1 Products affected

2 Type of change

The IEC-Standard has changed.
Therefore the 478X must have a new pressure plate.

478X					0118.2048	
Creation date:	Created by:	Release date:	Released by:	Notification No.	Index	Page
13.09.2010 11:04:41	SHA	22.03.2011	SHA	22159	a	1 von 1

3 Detailed description of change

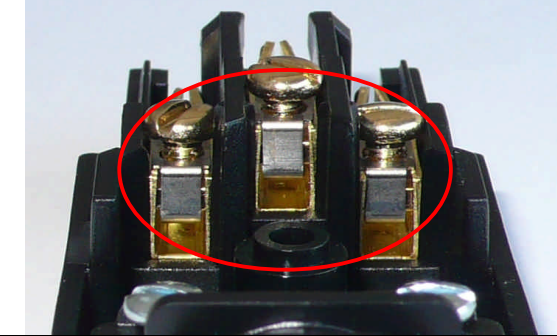
OLD: screw presses directly on the contact	NEW: pressure plate between screw and contact

Wiring through a screw. The flexible wire has tendencies to move on one side.	Wiring through a pressure plate. When the screw gets torqued, the pressure plate is pressing on the flexible wire.

According to the change of the standard EN/IEC60320-1 Amd.1, the parts are new checked with a withdrawal force of 30N. Before it was 20N. Otherwise the Standard EN/IEC60320-1 Amd.1 is not fulfilled.

Form: ----
Fit: ----
Function: Fulfilling of the Standard EN/IEC 60320-1 Amd.1
Production Site: New mounting à new pressure plate
